10744 Whitman Ave. N

EARLY DESIGN GUIDANCE RESPONSES |
MASSING / MODULATION - PREFERRED OPTION

RECOMMENDATION
06/03/2024 3040300-LU

N 109TH STREET | STREET-LEVEL FACADE

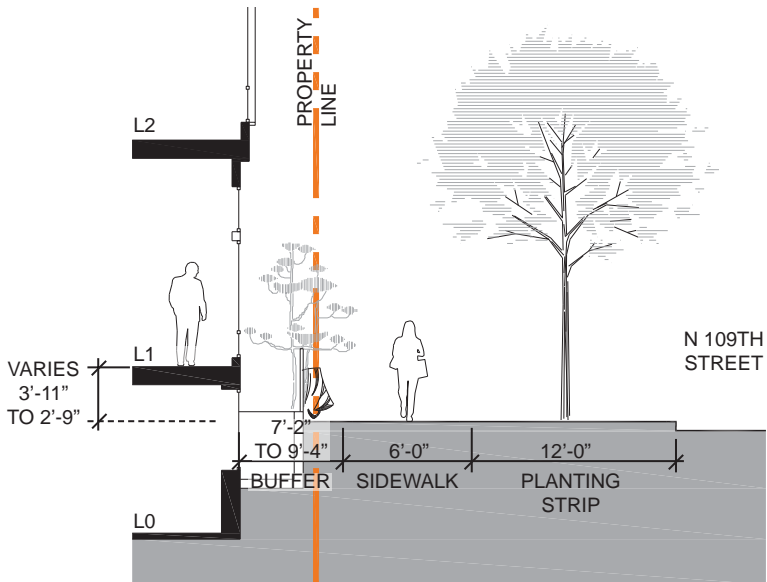
c) Board members recommended further study of the street level of the building along N 109th St. The Board members recommend the building's design along N 109th Street engage with the street as much as possible and the design intent on Whitman Ave should continue from that street to 109th St. Board members noted that the improvements to the adjacent street right-of-way will assist in improving the overall site conditions. The Board stated that improvements to N 109th Street should be paired with the existing building to the north for engagement and connection to the street.

The ground-floor façade facing N 109th St has been carefully considered to establish a rhythm of paired windows coupled with modest window wells to provide light to the lower-level units. Verdant landscaping between the sidewalk and building acts as a buffer while maintaining direct lines of sight for security and interaction. In contrast to the building to the north, the units are elevated above the sidewalk grade in accordance with the board's guidance, and the focus is on the landscaping and added street trees for an enhanced pedestrian experience with the building serving as a backdrop for neighbors and residents traveling between the building's primary entry on Whitman and Aurora Ave to the east. The proposed streetscape balances interaction through opportunities for eyes on the street and landscaping with privacy and safety for the residents by limiting entries and corners or recesses that could present safety concerns, particularly at this location within the city.

The streetscape along the 109th street frontage consists of a rich layering of textures to enhance the pedestrian experience. A combination of low shrubs, plantings, and hardy ground coverings flank the sidewalk and provide a buffer between the pedestrian realm and building. The building itself utilizes material with texture and human-scale details at the street-level to serve as a backdrop to the natural landscaping.

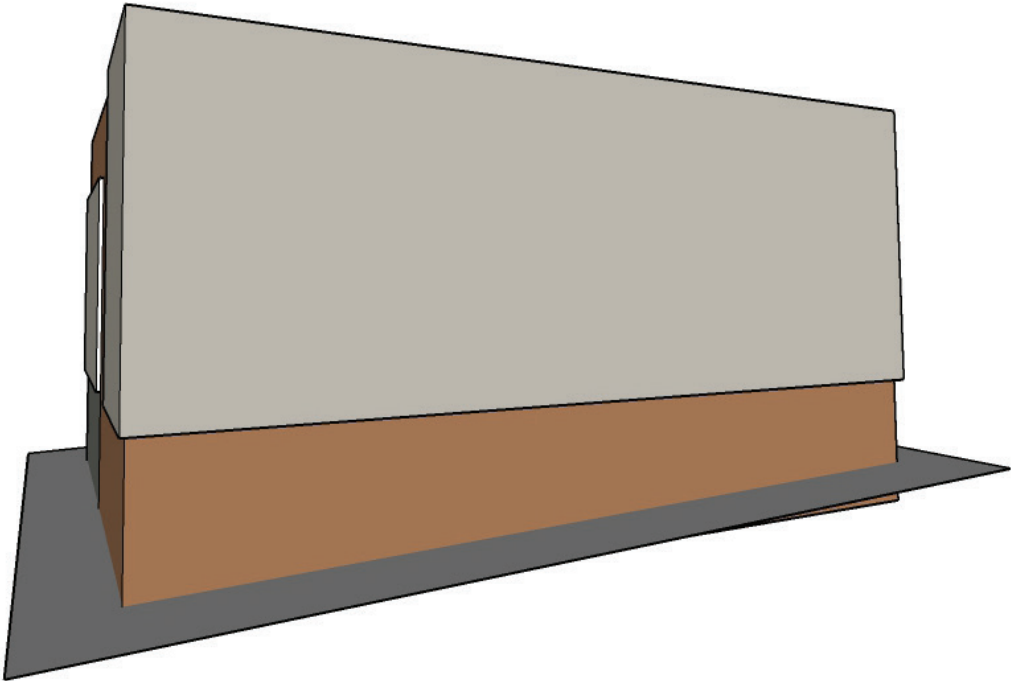
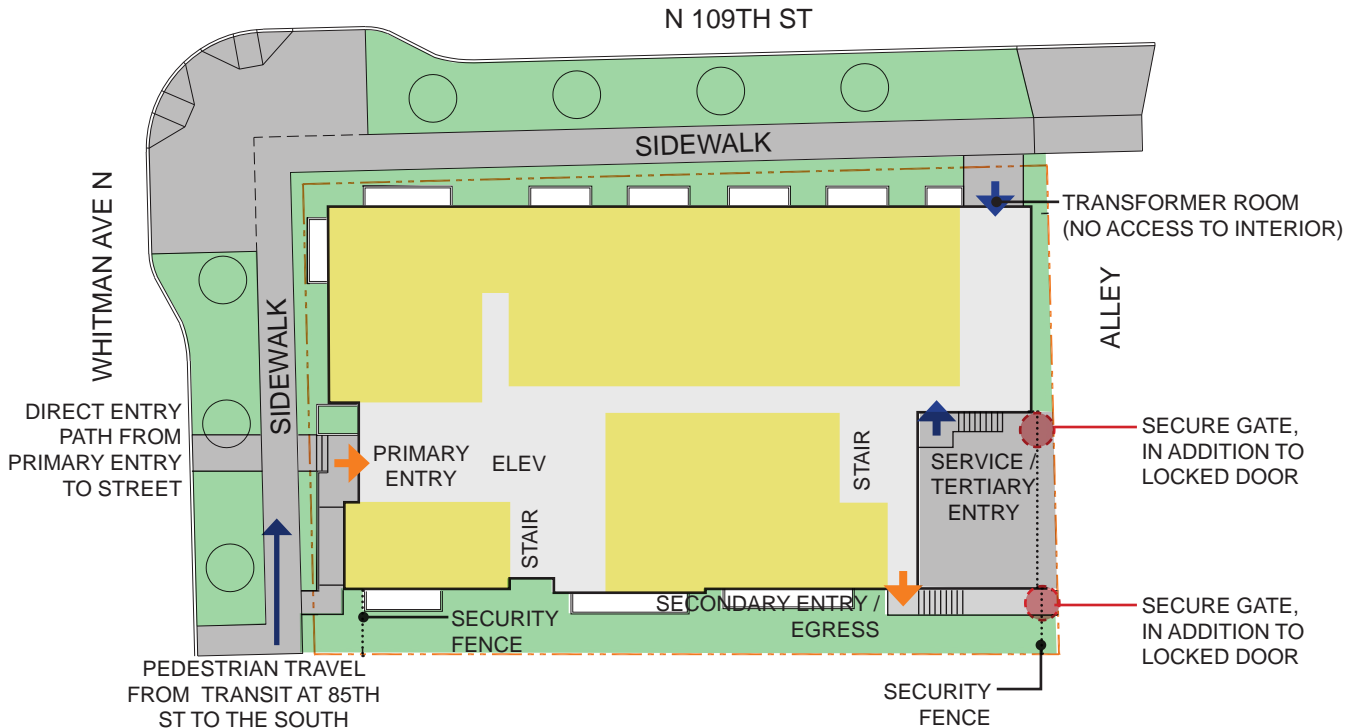
b) The Board requested the applicant study the street right-of-way improvements along Whitman Ave N and works with the Seattle Department of Transportation (SDOT) to allow a pedestrian path from the street, through the landscaping area between the street and sidewalk, to the main entry.

The proposal has a wide pathway through the planting strip on Whitman Ave N, aligning with the primary entry and connecting to Whitman Ave N. Additional, smaller scale walking paths are proposed between the street trees on the northern edge of the site, connecting the sidewalk to N 109th St. Coordination of this proposed hardscape within the ROW is ongoing with SDOT through the Street Improvement Permit (SIP) process.

109TH FRONTAGE | PROPOSED

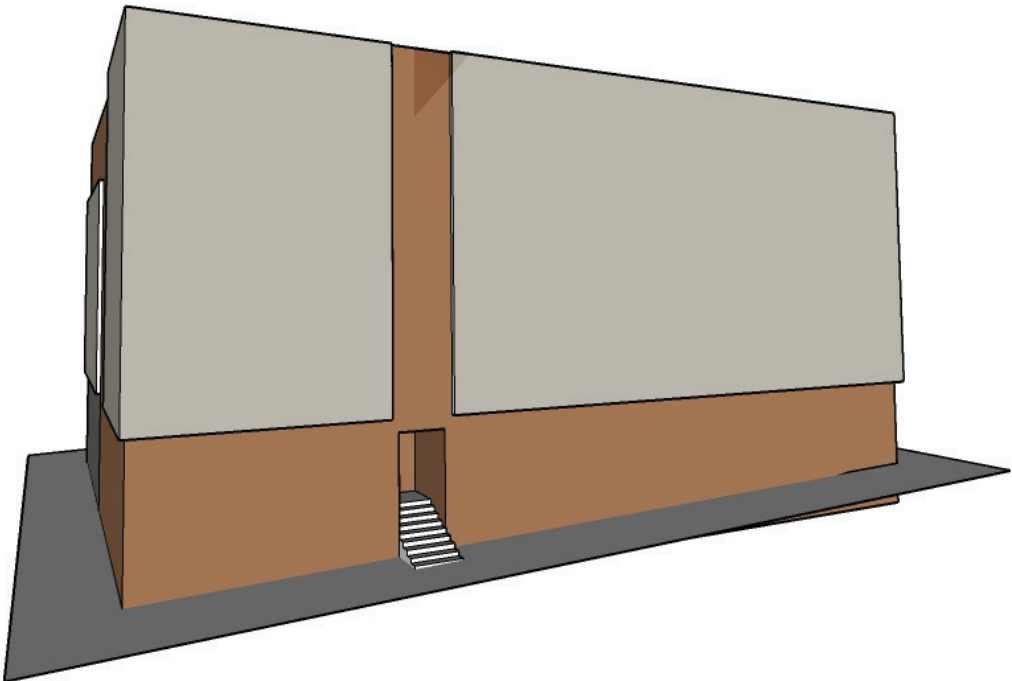
a) The Board recommended a secondary entrance and exit to the building be located along 109th Street to assist with creating better engagement along the street. To accommodate the secondary entrance the Board suggested the applicant explore changing the location of the building's stairway.

The design team carefully considered opportunities for a secondary entry along 109th but ultimately did not implement an entry directly to the street, in lieu of access via the alley instead. This decision was made after floor plan testing and analysis, and based on the impact to the project's objectives related to safety and security, anticipated use and access to the site, and unit yield and orientation. Adding an additional entry adds more points of entry that must be monitored and secured for the safety of residents. Having the entry open directly onto 109th with a recessed entry hampers security by creating corners and recesses as opportunities for unwelcome guests. Instead, the secondary entry is located on the east side of the building where an additional barrier via gates adds safety and security without closing off the building from the street frontage. Furthermore, given the location of transit at the intersection of 85th & Aurora and the automotive-focused nature of Aurora Ave, much of the pedestrian travel to and from the site is likely to occur along Whitman Ave and align with the proposed location and entry sequence of the primary entry. Lastly, while the team explored incorporating a secondary entry and corridor onto 109th St - including relocating the stair - it proved infeasible without impacts to the proposed program, both yield and the priority of facing as many units north and west towards the street frontages as possible.

- Maximizes amount of housing unit / project yield
- Increased security for residents due to less entry points into the building
- Facade at ground level lacks modulation or recesses where intruders could conceal themselves
- Visual interest is created through fenestration patterns, material choices and detailing, in contrast to hyper modulated building to the north and more appropriate for the scale of the facade.

MASSING / MATERIAL CONCEPT | NORTH AND WEST FACADES

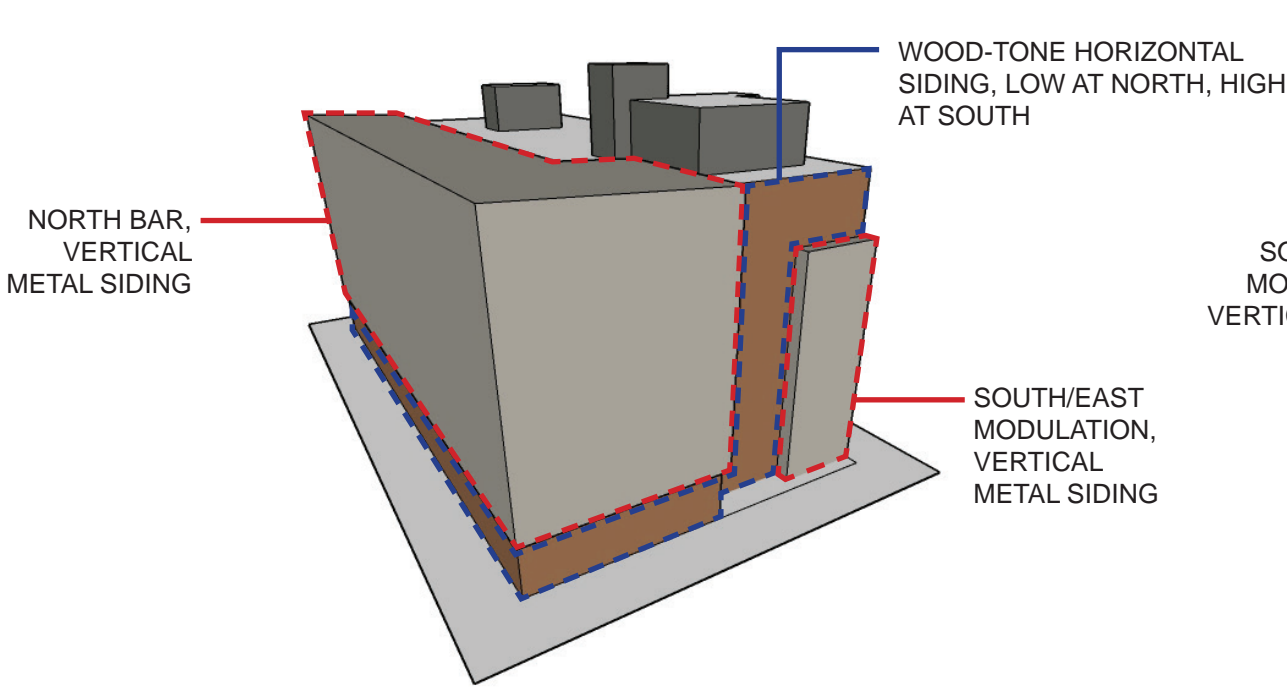
a) The Board supported the simple material palette proposed by the applicant. The Board recommended materials change with a change in plane on the building's façade and the material application be used to help break down the scale of the building. The Board requested details on the material application as it wraps around each façade of the building with Board members requesting the applicant pay particular attention to the materials wrapping around from the west to the south façade.

The proposed material palette remains simple and understated, emphasizing natural tones and reflecting the natural elements of the pacific northwest. The material distribution is a carefully thought out, deliberate expression that aligns with the overall massing partii with contrasting materials – both in tone and orientation (vertical vs. horizontal) - for the top and base volumes on the north façade. The material distribution flips on the south façade to reduce the perceived height, bulk, and scale. Care has been taken to coordinate the material shifts with the massing volumes, reinforcing the simple concept and expression.

REQUESTED DEPARTURE | RESIDENTIAL USES AT STREET LEVEL

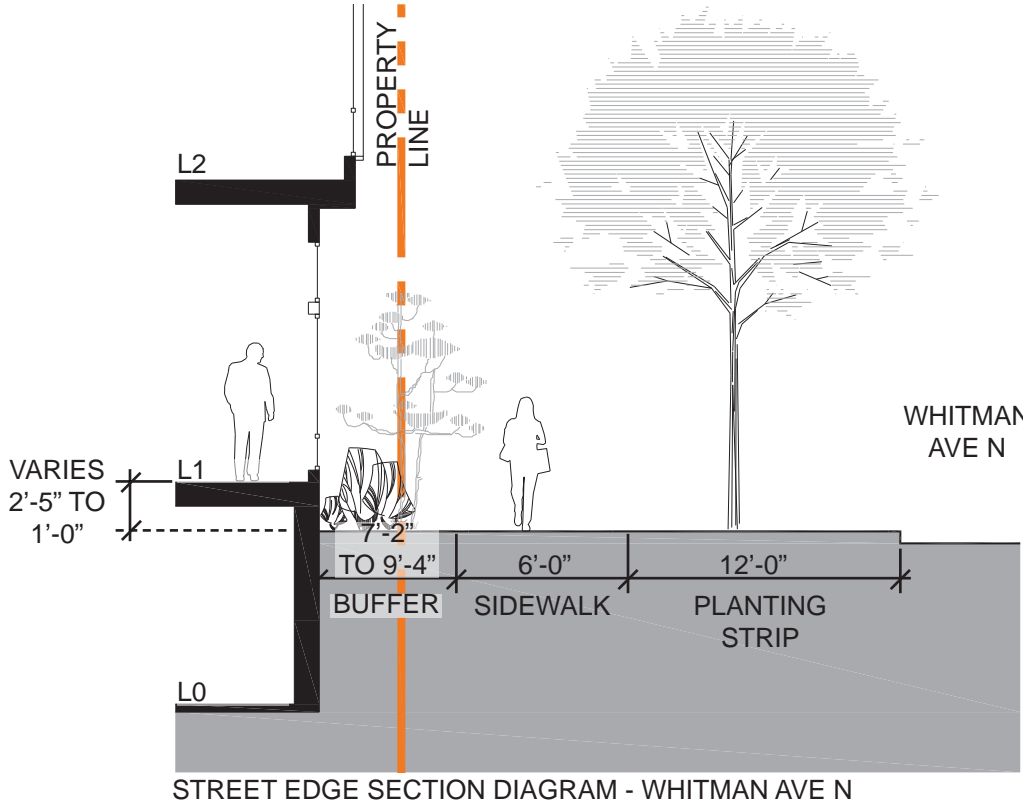
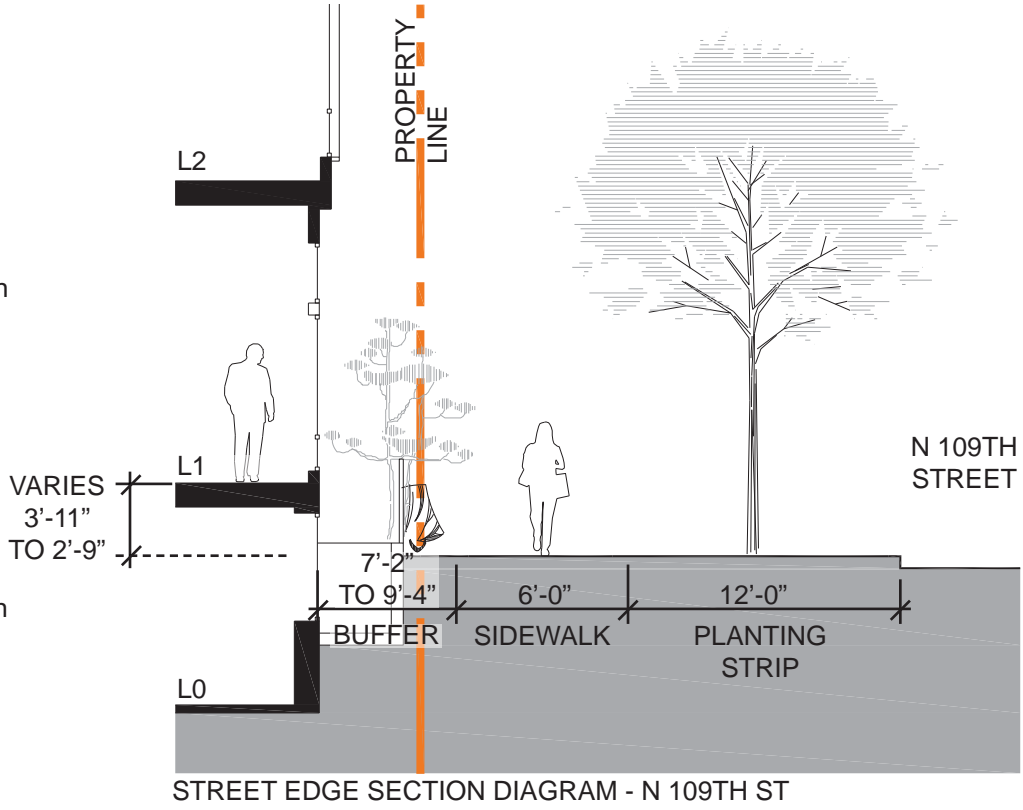
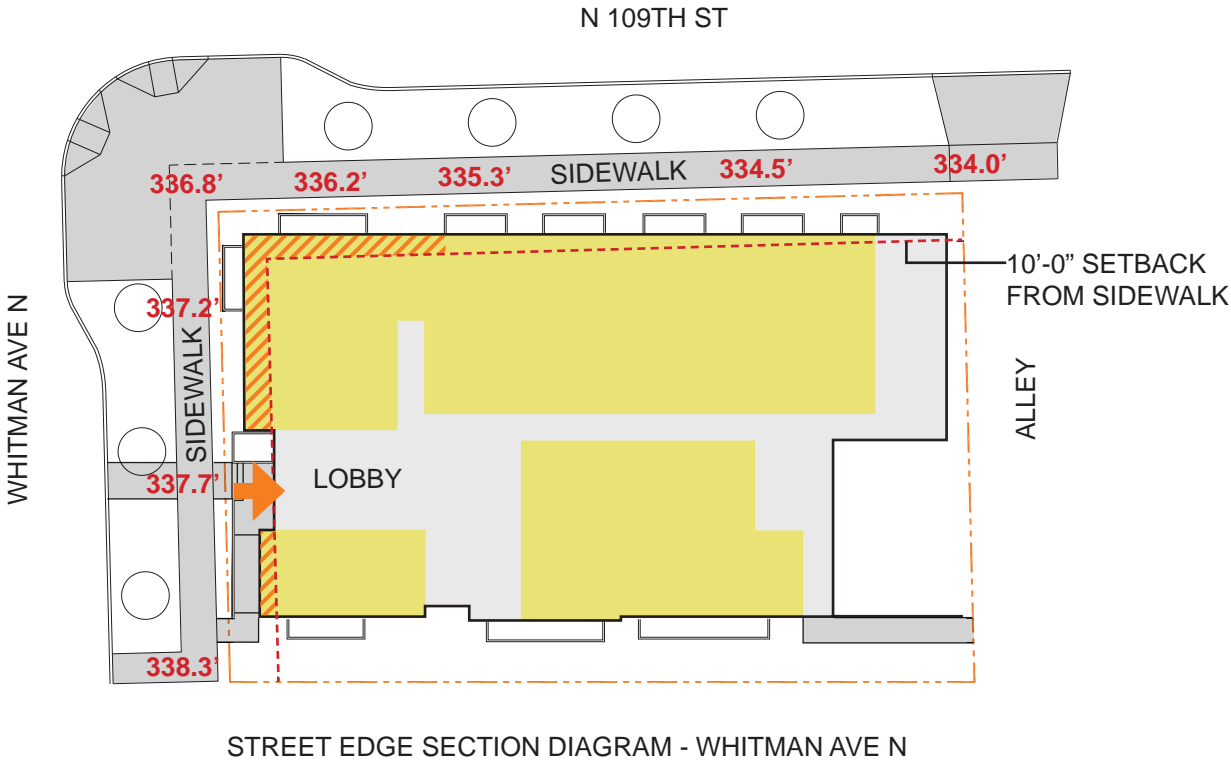
A departure is requested for the portions of the structure containing dwelling units that are located within 10'-0" of the sidewalk and or less than 4'-0" above the sidewalk grade. Along N 109th Street the structure abuts the right of way, and the building is set back from the property lines, but extends to within 6'-9" to 5'-3" of the proposed sidewalk location. The floor of the level 1 units is located above the adjacent sidewalk though due to the topography of the site, the exact elevation varies, between 3'-11" to 1'-0" above sidewalk grade. Along the 109th St frontage the grade slopes down west to east, and up from north to south along Whitman Ave N. The lobby and entry are located at the west facade, facing Whitman Ave. In order to maintain accessibility, the level 1 floor elevation is not 4'-0" above or below the adjacent sidewalk grades, and the facade is within the 10'-0" distance from the sidewalk specified by code.

- Along 109th, the combination of being both elevated above and set back from the sidewalk creates a semi-private space between the pedestrian and residential realms, while encouraging safety through "eyes on the street". (PL2-B-1, PL3-B-1, PL3-B-2)

- Strict compliance with the code could be met by stepping the building up to maintain the required 4'-0" change in elevation, however it would create a more significant staircase and substantial ramping along Whitman Ave at the primary entry, hampering accessibility for residents and weakening the connection between the entry and sidewalk. Due to the sloping topography maintaining a consistent relationship between the sidewalk and units would require internal stepping or levels within the building, further impeding accessibility for residents. (CS2-D-2, CS2-B-2, PL2-A-1, PL2-A-2, PL3-A)

- Robust landscaping is proposed within the space between the sidewalk and building. This landscaping is paired with the change in elevation to balance privacy and safety for residents with engagement of the public realm. (CS2-B-2, PL2-B-1, PL3-B-1, PL3-B-2, DC4-D-1)

REQUESTED DEPARTURE |
BLANK FACADE

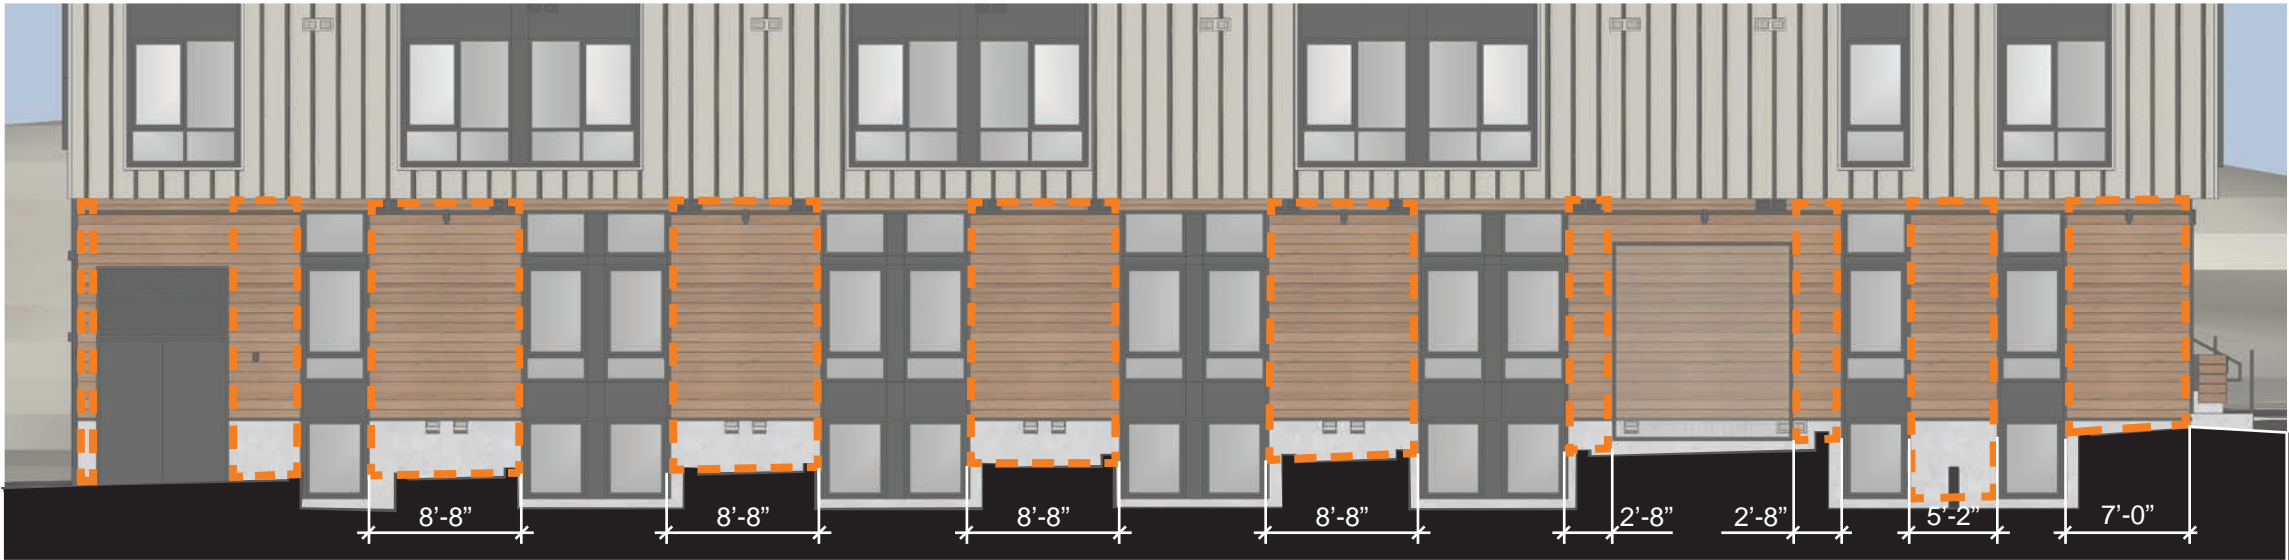
A departure is requested for the north facade at level 1, adjacent to N 109th street, where the blank facade is at 49%, approximately 9% of the code specified minimum.

- The use at L1 along the north facade is residential in nature - modestly sized congregate units that require some wall space for the functionality of the unit (furniture placement, venting, etc...). Furthermore, increasing the window sizes would decrease privacy for the residents and encourage the use of window coverings or films to achieve privacy, reducing the potential for “eyes on the street” and interaction between the residents and pedestrian realm, negatively impacting safety. (CS2-B-2, PL3-B-1, PL3-B-2)
- The proposed material at level 1 is a wood toned lap siding, adding human scale, texture, and visual interest. This facade treatment is layered with landscaping, including taller shrubs and specimen trees that will grow and obscure the portions of blank facade. (DC2-B-1, DC2-B-2, CD2-D-1, DC2-D-2, DC4-D-1)

N 109TH STREET FRONTAGE
BLANK FACADE SEGMENTS COMBINE TO APPROX 49%, OVER THE CODE MAXIMUM OF 40%, HOWEVER THE SEGMENTS ARE DIVIDED ACROSS THE FACADE, AND LANDSCAPING BETWEEN THE SIDEWALK AND THE STRUCTURE REDUCE THE PERCEIVED IMPACT OF THE “BLANK” WALL SEGMENTS
